**REPUBLIC AVIATION CORPORATION
FARMINGDALE, LONG ISLAND, NEW YORK
SERVICE DEPARTMENT**

SERVICE BULLETIN NO. 8

INSTALLATION TAIL WHEEL SIGNAL LIGHT SWITCH

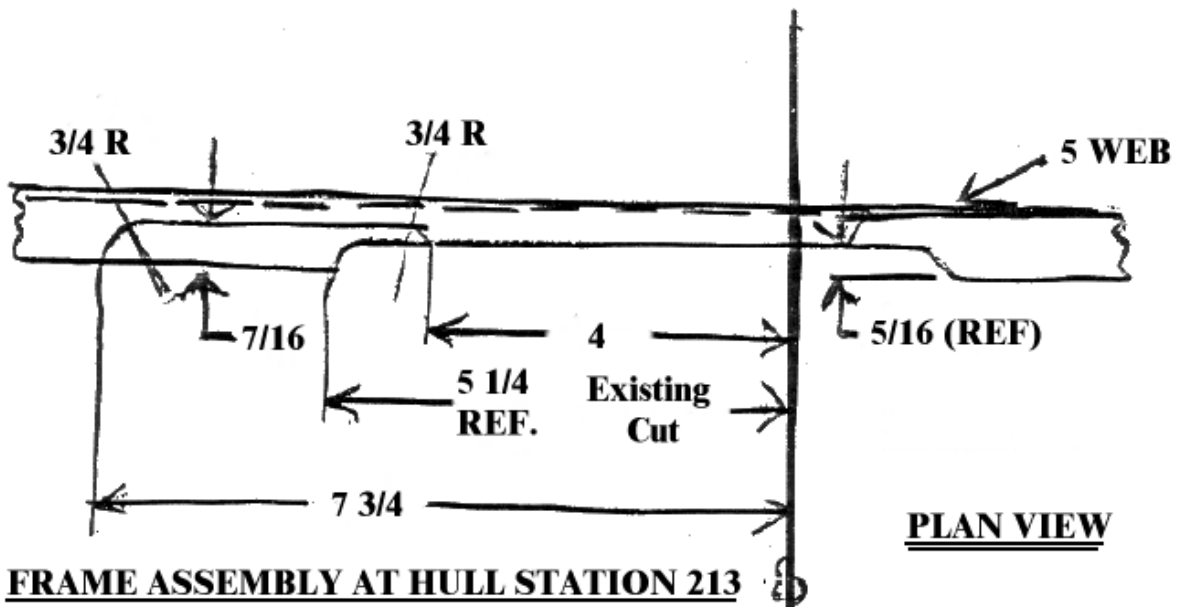
5. Referring to Fig. 1, remove ground strap #143 from the main landing gear down switch (17F82013-1) and attach wire #75 to the switch in place of the grounding strap just removed. Install switch.

Figure 2

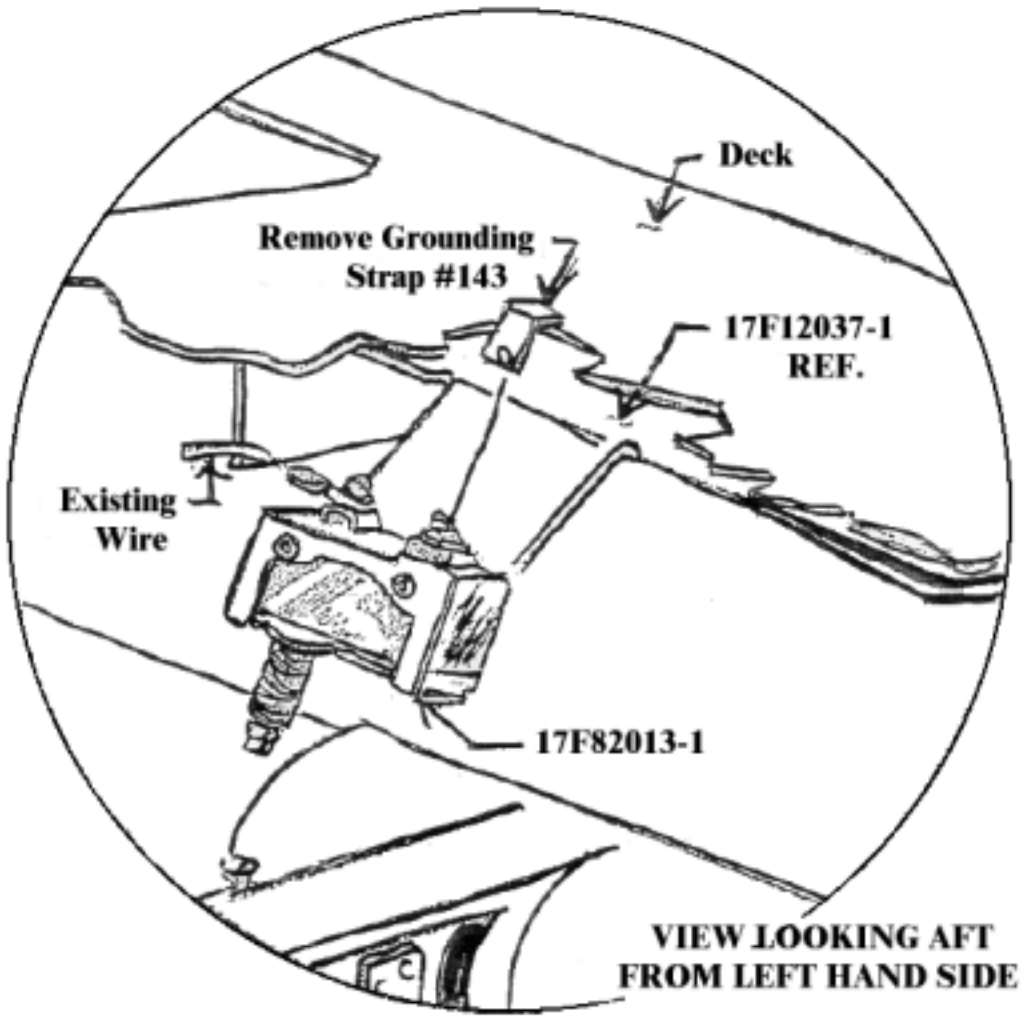
7. Increase cut-out in frame assembly at hull station 221.31 to provide necessary clearance for tailwheel signal switch as shown in Figure 2.

Figure 3

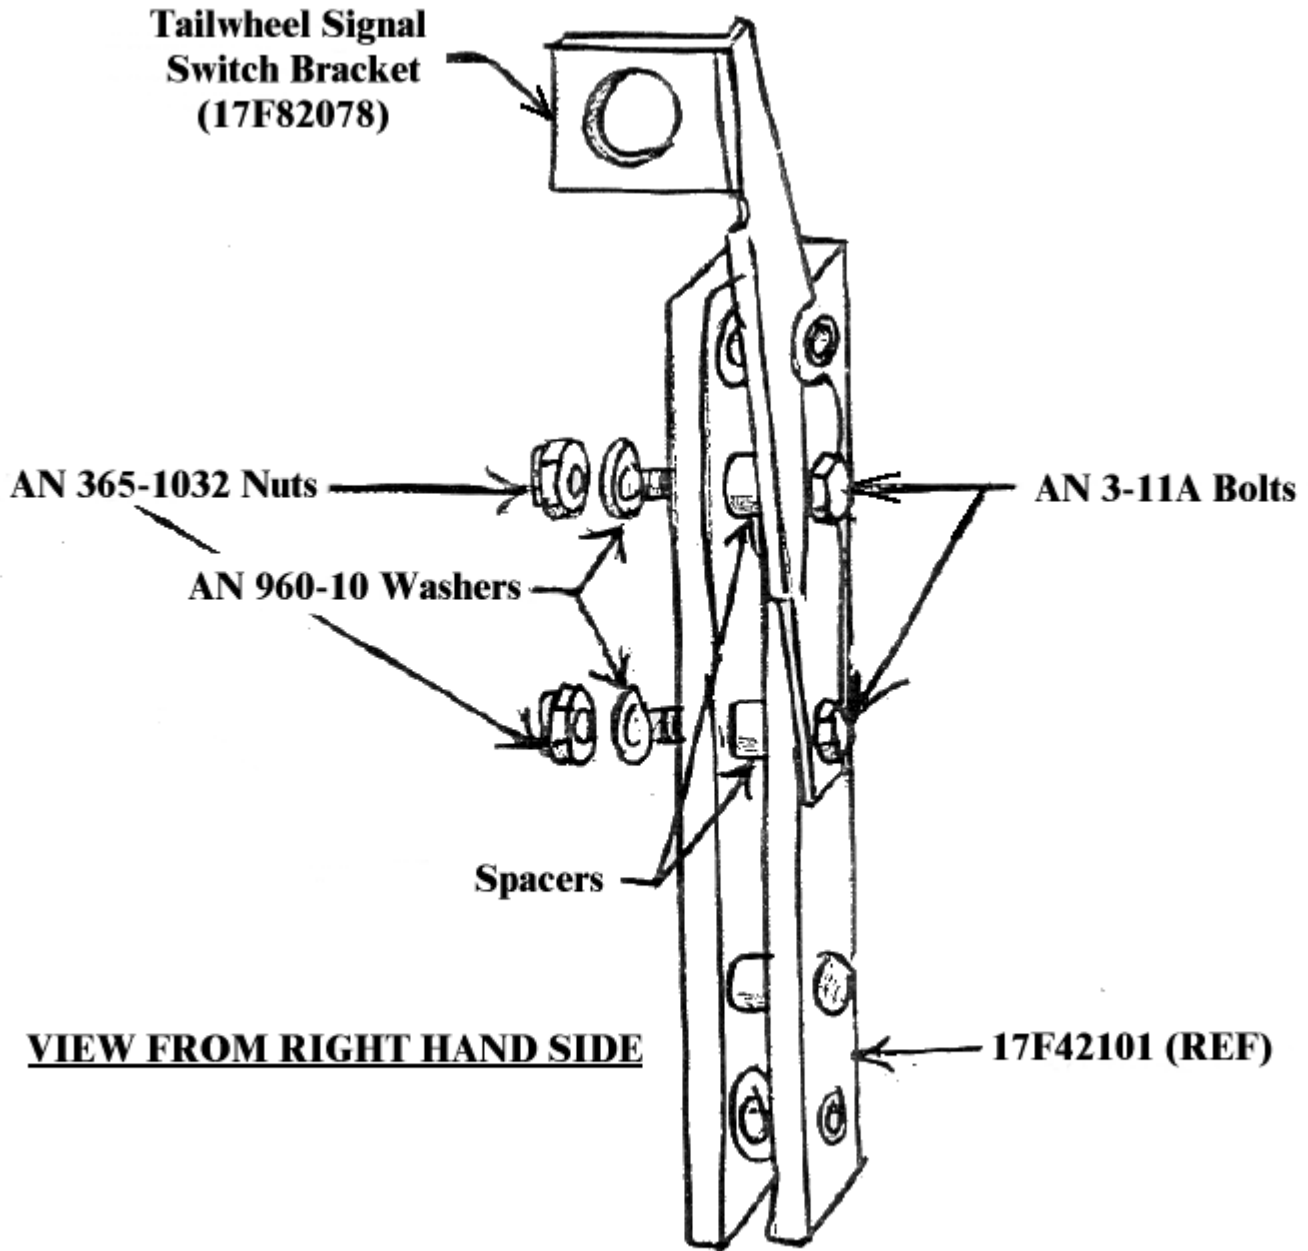
8. Remove the lower tail wheel actuating link assembly 17F42101 and drill out two upper 3/16" rivets, saving the spacers between the links. Use extreme care not to elongate holes. Locate the new tail wheel signal switch bracket 17F82078 on the forward side of the link assembly with the offset to the right and attach with two AN3-11A steel bolts, original bushings between links, AN960-10 washers and AN365-1032 nuts. Refer to figure 3 for bracket installation.

NOTE: Some of the earlier airplanes had a .260 spacer between the links instead of a .322 spacer. In this case use an extra AN960-10 washer between the nut and the link.

Figure 4

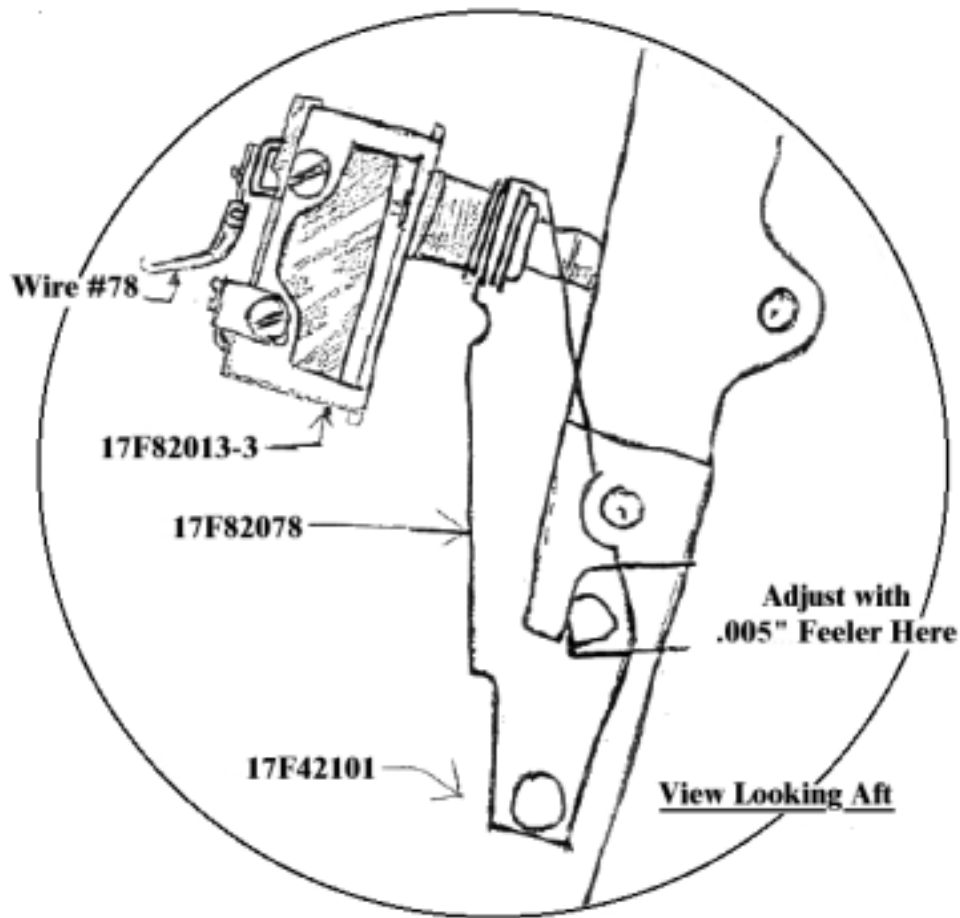
9. Install new Switch Assembly 17F82013-3 to bracket just installed, remove paint under nuts for electric ground. Reinstall link assembly and connect wire #78 to upper terminal screw. With links in down locked position, adjust switch to "make" contact with .005" feeler between upper link and stop on lower link. Refer to Figure 4.

NOTE: Master switch and battery switch must be "ON" (closed) to check tail wheel signal switch adjustment.

Figure 5

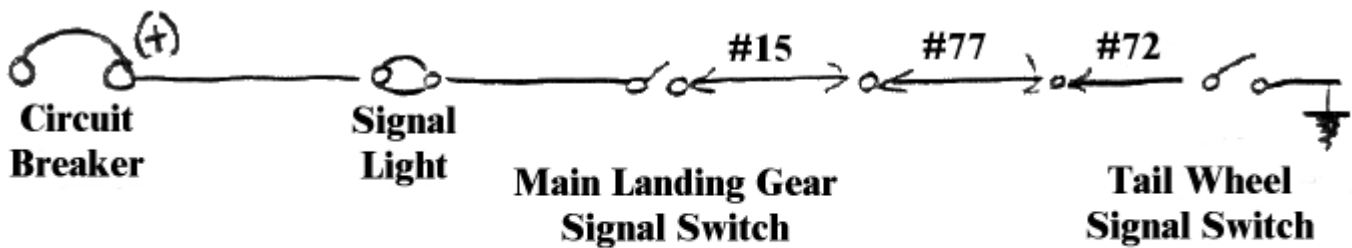
6. Install wires #75, #77 and #78 following the routing of existing wiring to aft end of airplane (refer to Fig. 5). Use 17F82041-2 sleeves to cover wire terminals (where one wire joins the next). Existing clamps in the region of wire #78 which pass through the compartment just forward of the tail wheel bulkhead from Tinnerman A2981-S-2 to A2981-S-3 if necessary. The existing clamps may be too small.
